Suggestions for DIGSS V1.1 Revisions

Gord Harris – Christie Digital - Jan 15/2015

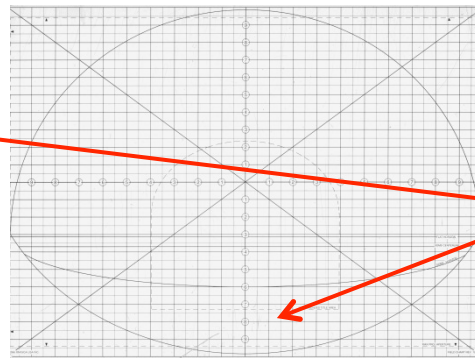
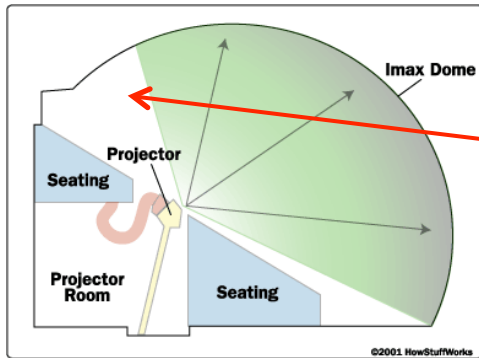
- Perhaps it's worth adding a further goal along the lines of "to clearly differentiate GS theatres from typical commercial digital cinemas and home cinema experiences." If we get too similar to premium typical "movie theatres" we are in danger of losing the brand of giant screen.
- We must aspire to better than UltraHD (four times HD resolution) TVs now available at home!
- Section B background – we might add note that aspect ratio is not exactly 4:3 but SMPTE standard 419M-2005 projected Aspect Ratio is 1.433:1 (not 1.33:1)
- Not every theatre screen masks identically and at least in IMAX® theatres we established a MIN IMAX (safe action area for titles) and MAX IMAX image area for camera viewfinders so we should note there is a tolerance here.

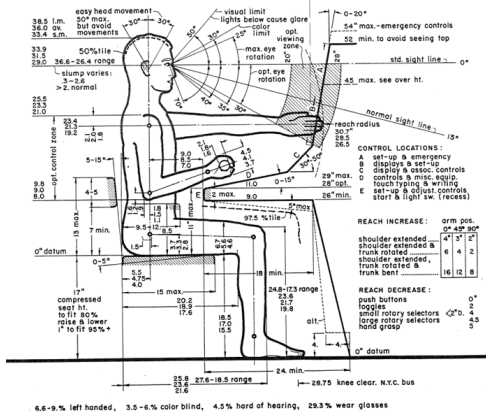
- Needs a header or set-up note on “how to measure” that states that projector and lamps should be on for a minimum 20 minutes before all measurements, and the room lights turned off. The projector must be calibrated per Table A1 in SMPTE RP 431-2-2011 before the final measurements are made.
- Ideally the ambient light level on the screen should be less than 0.01 fL (aspirational).
- A1 I’m not sure why you call it 1.33:1 as the SMPTE standard 15p70 is 1.433:1.
- I personally disagree with recommending 1.85:1. A key aspect and principle of the original IMAX theatre designs was a good look down angle and wide VFOV. From ergonomics theory this look down angle and VFOV is very important – see here:
